ENCLOSURE 1
TO SERIAL: NLS-85-415

PROPOSED TECHNICAL SPECIFICATION PAGES
BRUNSWICK-2

SUMMARY LIST OF REVISIONS

FIGURE 3.2.3-1

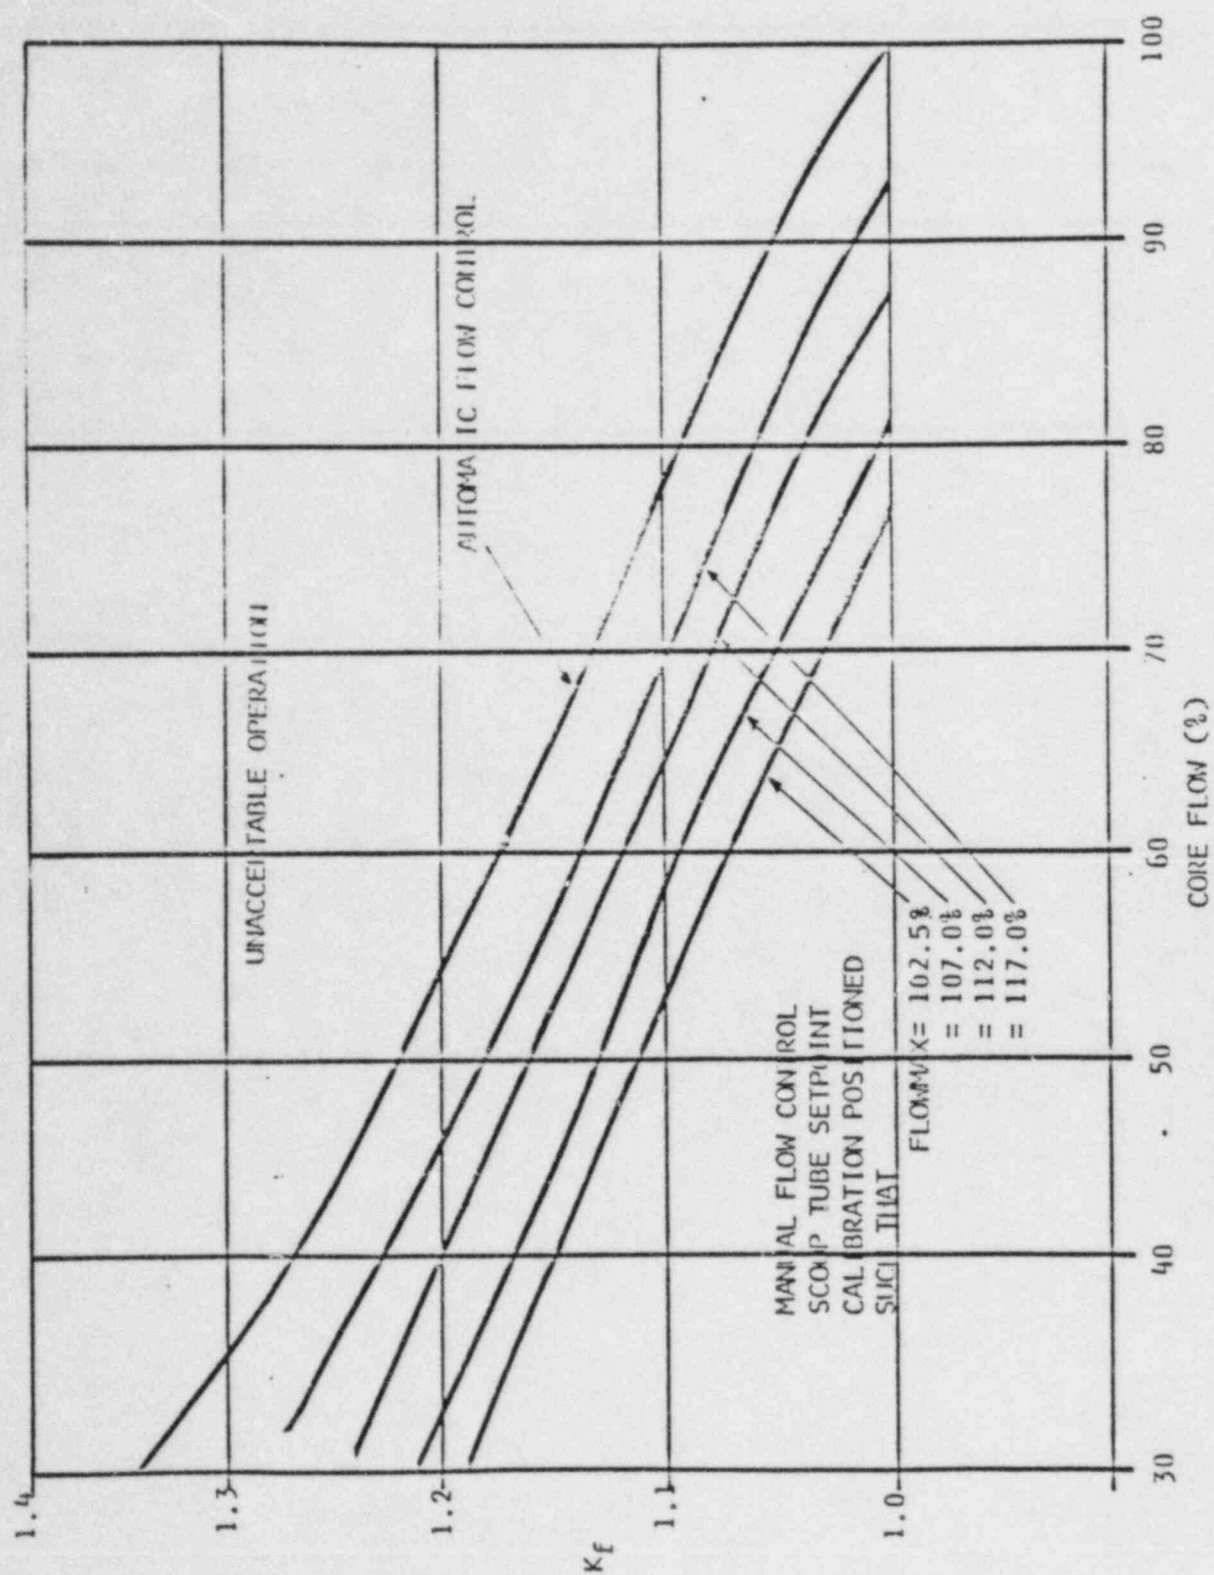
| <u>PAGE NO.</u> | <u>DESCRIPTION OF CHANGES</u> |
|-----------------|--|
| 3/4 2-8 | Removed the MCPR limits for the 8 x 8 fuel type. Revised the remaining MCPR limits. Repaginated. |
| 3/4 2-12 | Revised MCPR limit valves. Combined turbine trip and feedwater control failure transients into a single pressurization transients category. Removed MCPR limits for the 8 x 8 fuel type. Repaginated. |

3.2.3.1 The MINIMUM CRITICAL POWER RATIO (MCPR), as a function of core flow, shall be equal to or greater than the MCPR limit times the K_f shown in Figure 3.2.3-1 with the following MCPR limit adjustments:

- a. Beginning-of-cycle (BOC) to end-of-cycle (EOC) minus 2000 MWD/t with ODYN OPTION A analyses in effect and the end-of-cycle recirculation pump trip system inoperable, the MCPR limits are listed below:

1. MCPR for 8 x 8R fuel = 1.31
 2. MCPR for P8 x 8R fuel = 1.33
 3. MCPR for BP8 x 8R fuel = 1.33
- b. EOC minus 2000 MWD/t to EOC with ODYN OPTION A analyses in effect and the end-of-cycle recirculation pump trip system inoperable, the MCPR limits are listed below:

1. MCPR for 8 x 8R fuel = 1.41
 2. MCPR for P8 x 8R fuel = 1.44
 3. MCPR for BP8 x 8R fuel = 1.44
- c. BOC to EOC minus 2000 MWD/t with ODYN OPTION B analyses in effect and the end-of-cycle recirculation pump trip system inoperable, the MCPR limits are listed below:

1. MCPR for 8 x 8R fuel = 1.29
 2. MCPR for P8 x 8R fuel = 1.29
 3. MCPR for BP8 x 8R fuel = 1.29
- d. EOC minus 2000 MWD/t to EOC with ODYN OPTION B analyses in effect and the end-of-cycle recirculation pump trip system inoperable, the MCPR limits are listed below:

1. MCPR for 8 x 8R fuel = 1.29
 2. MCPR for P8 x 8R fuel = 1.32
 3. MCPR for BP8 x 8R fuel = 1.32
